Access Compliance Report

Public Rights-of-Way

(Curb Ramps)

| Intersection ID: 16682 | Main Street: MARSH_RD | Cross Street: LEASIDE_LN | Location: | N |

| ADA ID: 512D5E405E69 | Ramp Type: PerpDiag | Initial Pass/Fail: Fail | Overall Compliance: No | Severity Score: 37.5 |

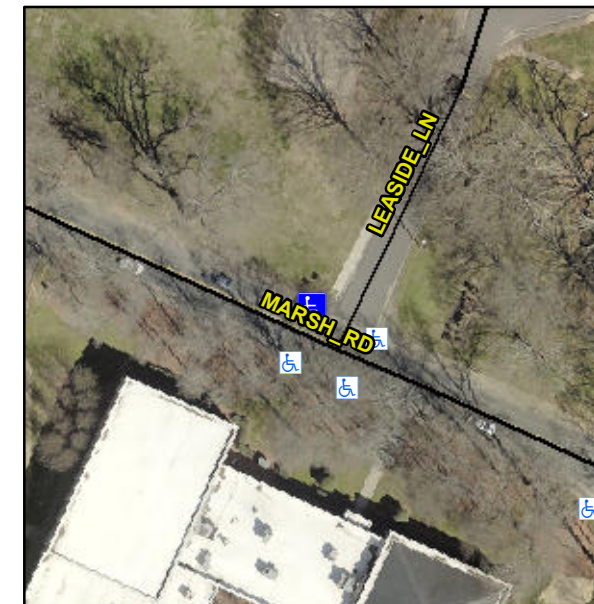
Not Found, R304.2.2, R304.5.3

| Compliance | Description | Data | Compliance | Description | Data |
|------------|-----------------------|-------|------------|-----------------------------|-------|
| N/A | Ramp Length (in) | 52.0 | No | Ramp Slope (%) | 19.0 |
| Yes | Ramp Width (in) | 48.0 | No | Ramp XSlope (%) | 6.4 |

Remove & Replace Curb Ramp With Two New Directional Ramps or Equivalent.
